**Re: FortisBC Energy Inc. (FEI)**  
**2022 Long Term Gas Resource Plan (LTGRP) – Project No. 1599324**  
**Response to the Residential Consumer Intervener Association (RCIA)**  
**Information Request (IR) No. 2**

FortisBC Energy Inc. (FEI or the Company) 2022 Long Term Gas Resource Plan (LTGRP) (Application)	Submission Date: May 3, 2023
Response to Residential Consumers Intervener Association (RCIA) Information Request (IR) No. 2	Page 1

**Figure 1: Annual Demand Scenarios – Residential, Commercial, and Industrial Customers after the Exclusion of New Customers (Pre-DSM Demand)**

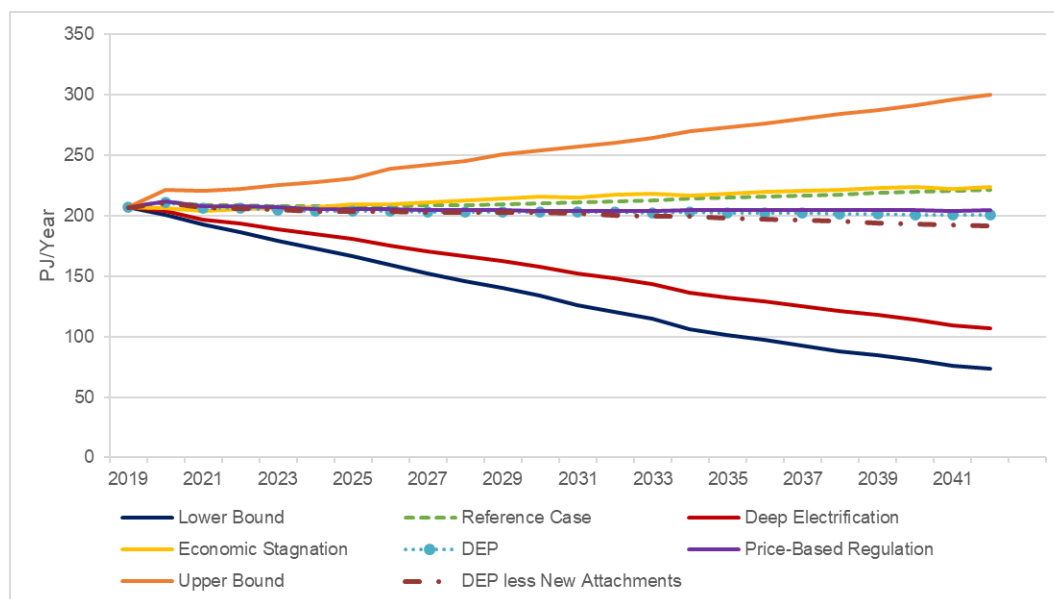
38.4 Please re-file Figure 4-9 on page 4-28 from the Application showing the change in annual demand if FEI ceased or was otherwise precluded from attaching any new customers across its territory beginning in 2030.

Figure 1 below provides an updated version of Figure 4-9. The original DEP dataset is shown alongside the DEP dataset after the demand for new customers is excluded. The updated data is based on the calculations provided in the response to RCIA IR2 38.3.

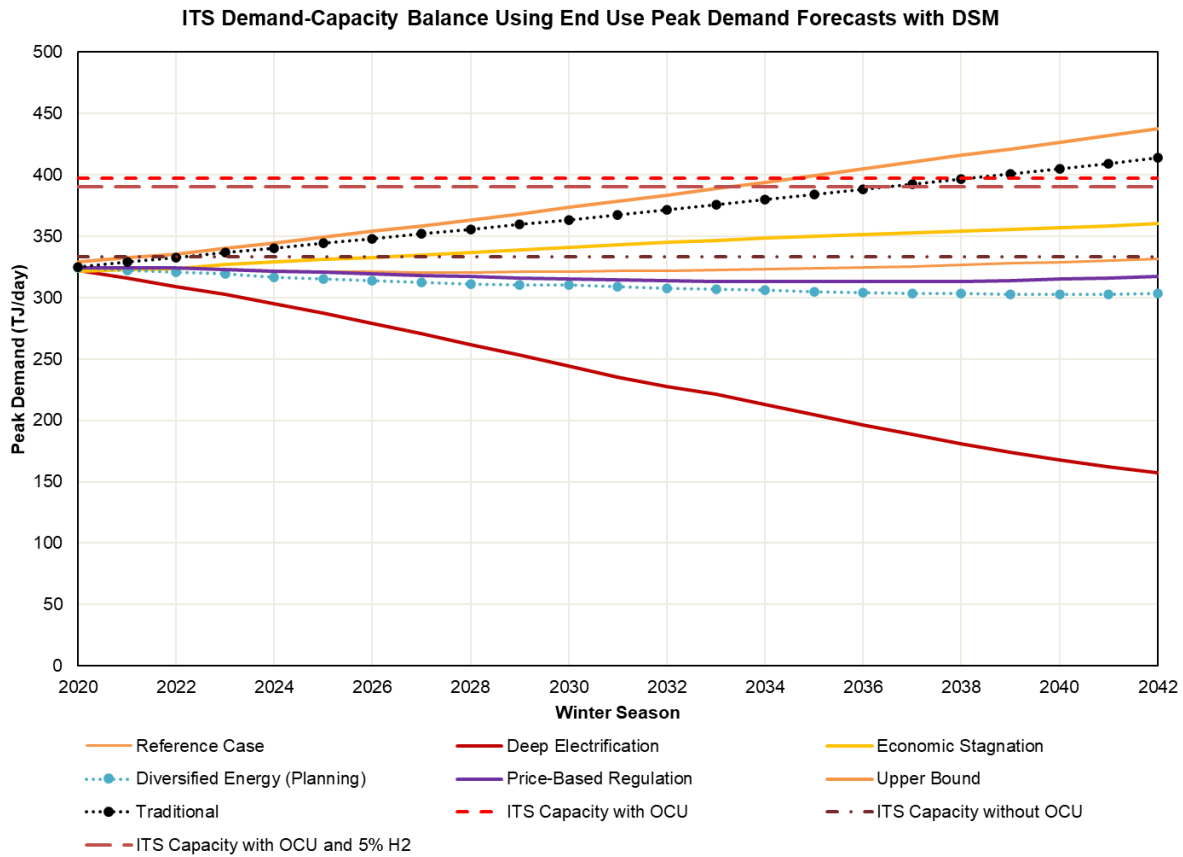
43.1 Please file versions of the figure from BCSEA 21.13 showing the ITS capacity with and without OCU assuming i) a 5% blend of hydrogen and ii) a 30% blend of hydrogen.

To prepare a version of the requested figure with 5 percent and 30 percent blends of hydrogen, FEI assumes both Westcoast and TC Energy have the capability of transporting and delivering those levels of hydrogen to FEI's transmission system taps at both Savona and Yahk. This would also imply that the Southern Crossing Pipeline (SCP) will flow the blended gas mixtures and send a portion of the gas towards the Okanagan, and the remaining gas to Kingsvale to be injected into the Westcoast system.

1 The figure below shows the ITS capacity with a 5 percent blend of hydrogen with the OCU project  
2 in service. The hydraulic model presents that, without the OCU project, the ITS does not have the  
3 capacity to receive a 5 percent blend of hydrogen from Savona and Yahk, hence the capacity line  
4 for this scenario is not shown on the figure. FEI also simulated a 30 percent blend of hydrogen  
5 and found that even at existing levels of demand, substantial upgrades at the Kitchener and  
6 Kingsvale compressor stations would be required and as such, the capacity line for the 30 percent  
7 blend of hydrogen is also not shown on the figure below.

**Figure 1: Updated Figure 9-7 for Cumulative Effective Rate Impact (2022 – 2042) – Residential RS 1, Average UPC 60 GJ**

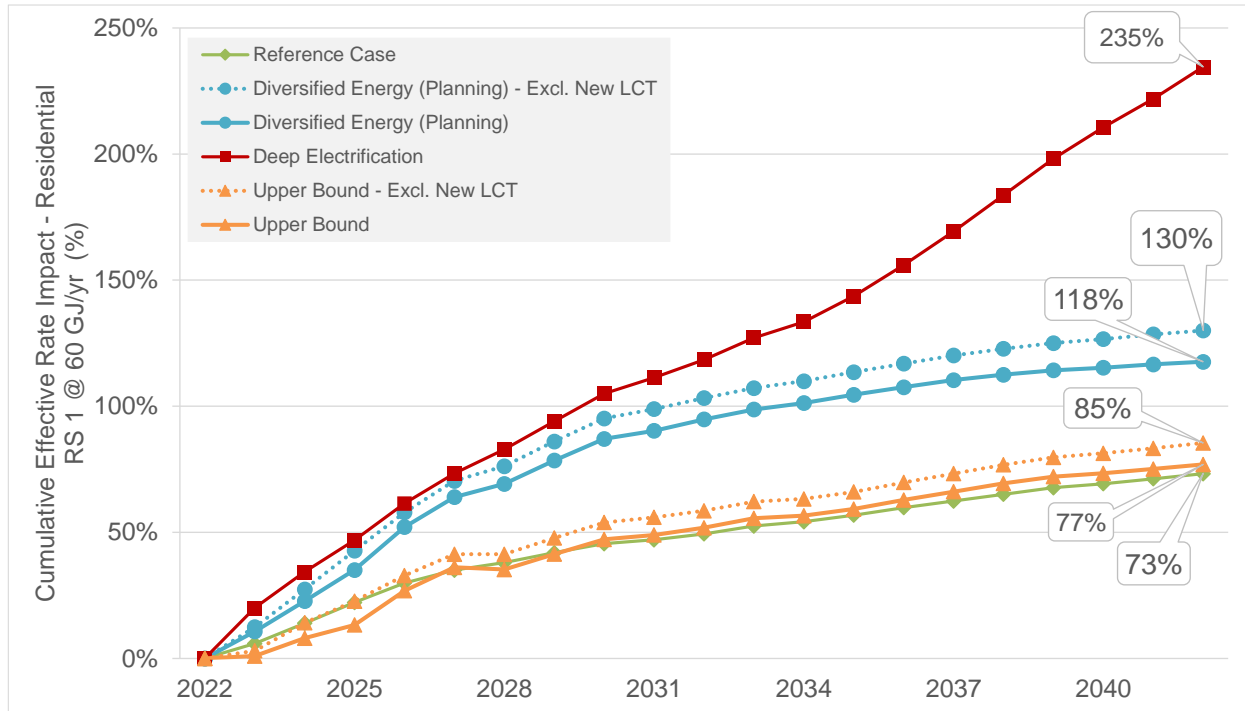
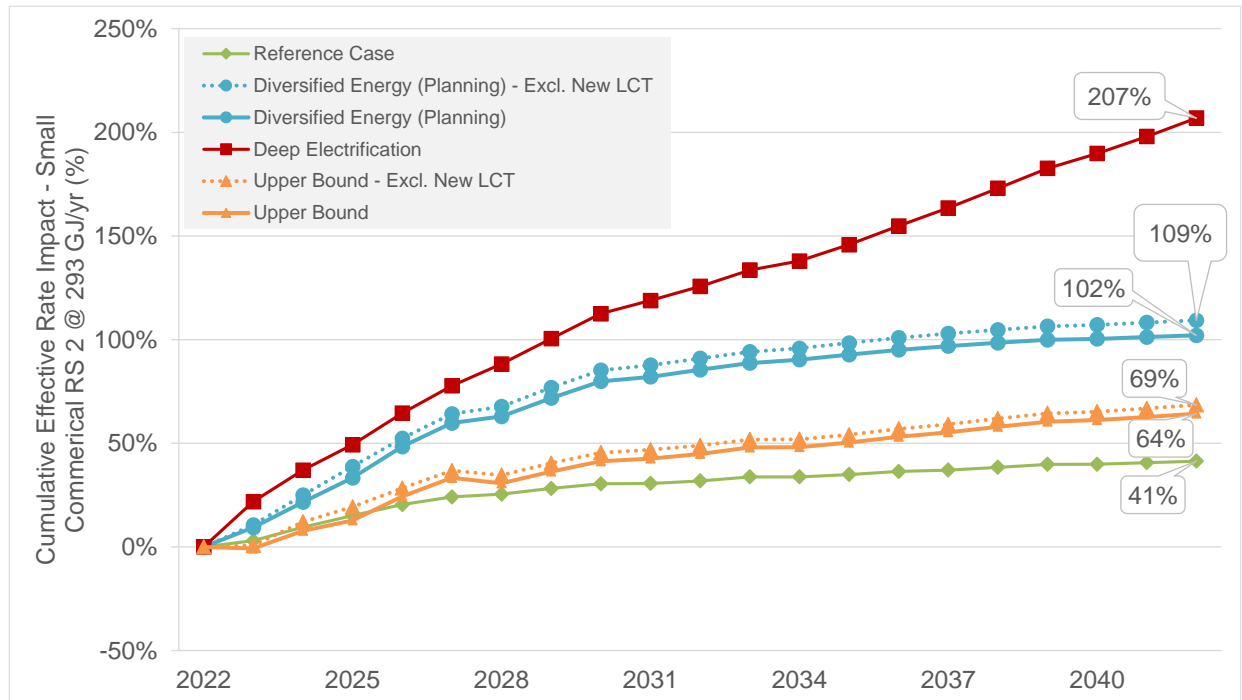
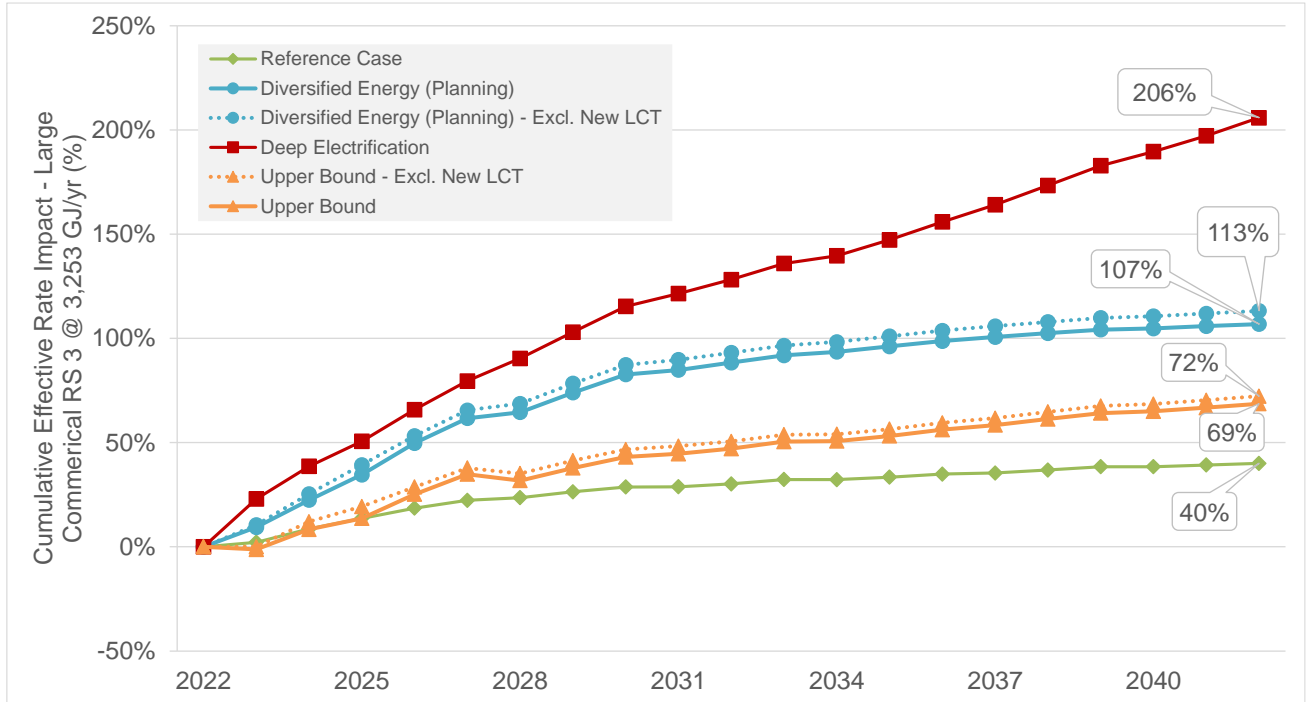
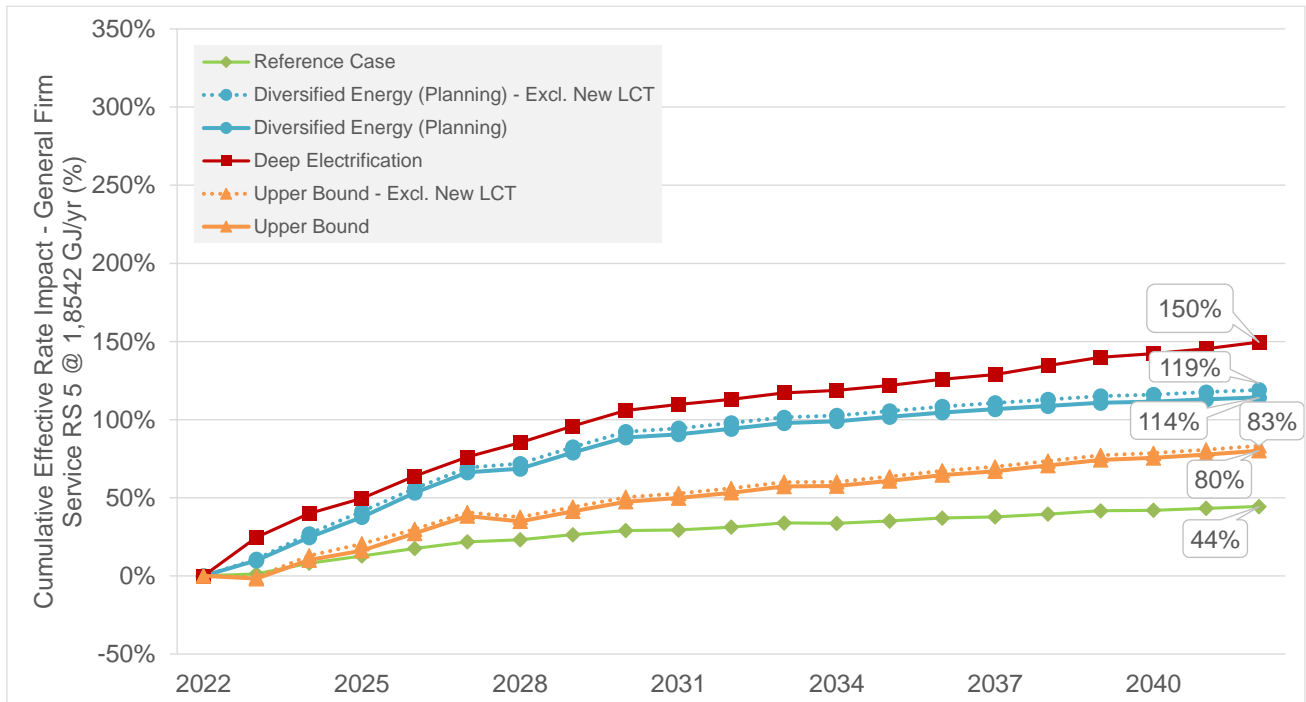
49.3.1 Please show how the bill impacts would change by plotting additional curves on Figures 9-7 to 9-10 and adding a column to Table 9-2 to show the Diversified Energy Planning scenario but without the expenditures and corresponding revenues from additional LCT sales.

FEI confirms the impact from the Tilbury Phase 1B Project has been included in the rate impact analysis shown in Section 9.4 of the Application and is also reflected in Table 1 of the response to BCUC IR1 75.5 as referenced in the preamble above. As discussed throughout the Application and also demonstrated in Table 1 of the response to BCUC IR1 75.5, the offsetting revenue resulting from new LCT sales will provide an overall benefit to all of FEI's customers. It can be seen from Figures 1 to 4 below, which are re-creations of Figures 9-7 to 9-10 of the Application and include the scenarios without new LCT developments and sales (dotted line), and also from Table 2 below, which is a re-creation of Table 9-2 of the Application, if FEI did not pursue the Tilbury Phase 1B Project, the cumulative rate impacts to FEI's customers would have been higher.

*Figure 3.16 – average heating COP range of all heat pumps vs. outdoor temperature.*

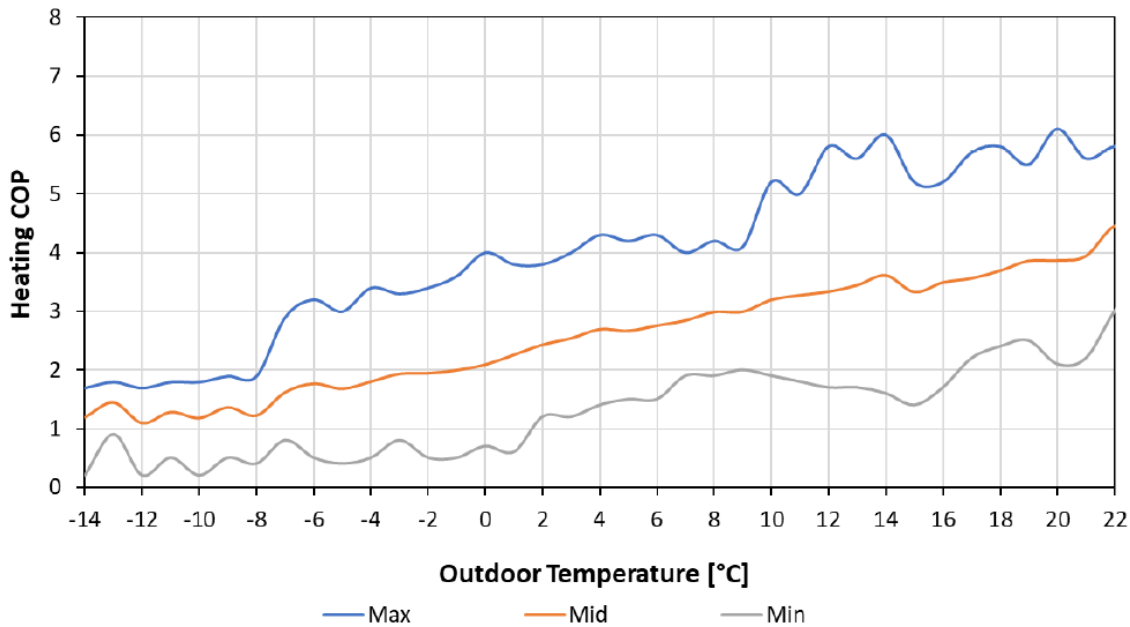
5 Heat pumps, and their efficiencies as currently represented in the BC Cold Climate  
6 Field Study, essentially provide the same efficiency as electric resistive heating at  
7 temperatures below approximately -18 C, while the average daily temperature for  
8 Kelowna during the winter can be -26 C or lower (with nighttime temperatures well  
9 below -30 C). Accordingly, at temperatures colder than -18 C for the 25 percent  
10 and 50 percent electrification cases, and at temperatures colder than -20 C for the  
11 100 percent electrification case,<sup>11</sup> it is assumed that heating load is served through  
12 the auxiliary / resistive heating mode on the heat pump or by less-efficient electric  
13 heating appliances.<sup>12</sup> The thermal efficiency gain for heat pumps discussed in the  
14 above bullet reduces the gas-to-electric conversion only up until those points; after  
15 that, the efficiency improvement is lost.

22 FEI confirms that the model accounts for the declining heat pump performance based on Figure  
23 3-16 from the Cold Climate Heat Pump study, reproduced below:

For example, the “Max” efficiency heat pump setting used in the 100 percent electrification case has a heating COP of approximately 3.0 at -5 C, declining below a COP of 2.0 beginning at -8 C.

**Figure 3-5: City of Kelowna - Electricity and Gas Demand by Temperature in 2040 with 100 Percent Electrification<sup>17</sup>**

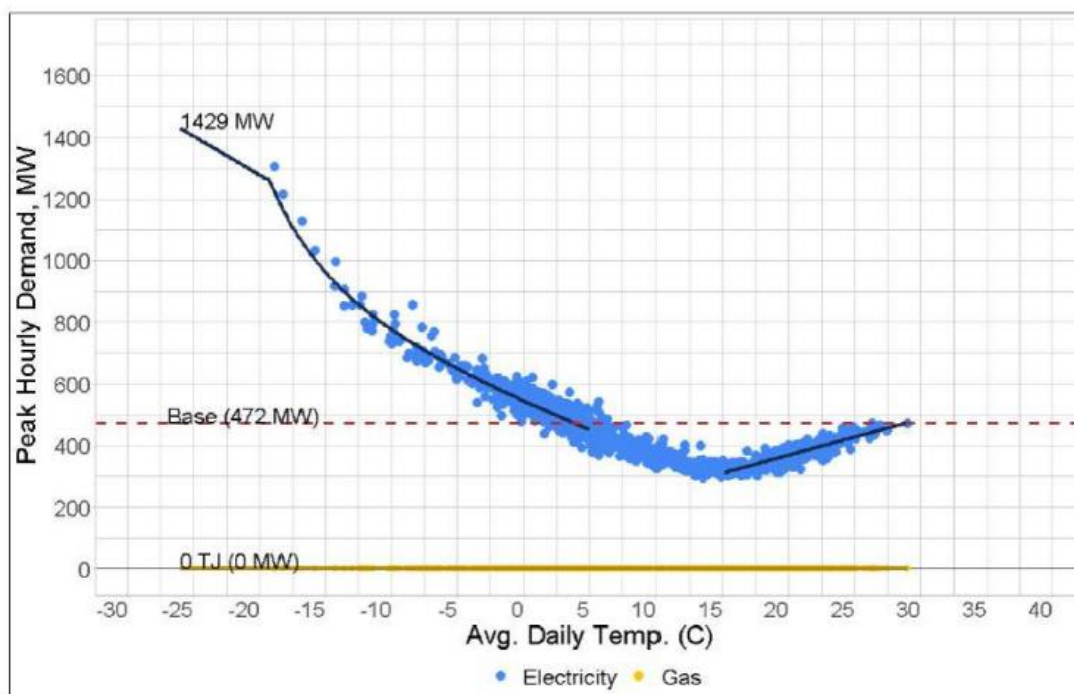
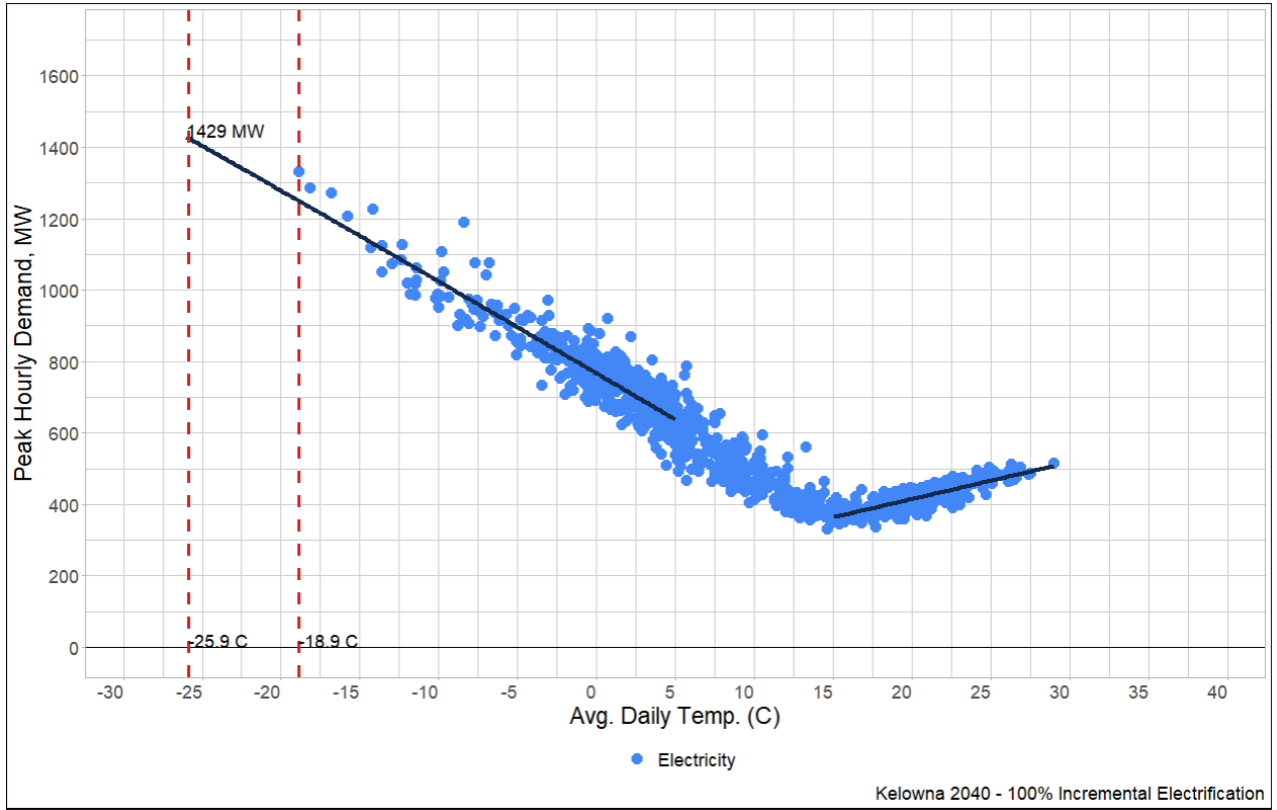
53.1 Please explain how FEI extrapolated the peak hourly demand curve to a temperature less than -18 C, which appears to be the lowest temperature data point in Figure 3-5.

In the model used for the Kelowna Electrification Case Study, FEI applied a linear regression to the observed load data versus temperature points from 2018 to 2020. As shown in the figure below, the coldest mean daily temperature recorded between 2018 and 2020 was -18.9 C. The design temperature for Kelowna is -25.9 C, and therefore, FEI extended the regression line to -25.9 C. FEI notes that the mean daily temperature recorded at the Kelowna Airport on December 22, 2022, was -26.2 C.
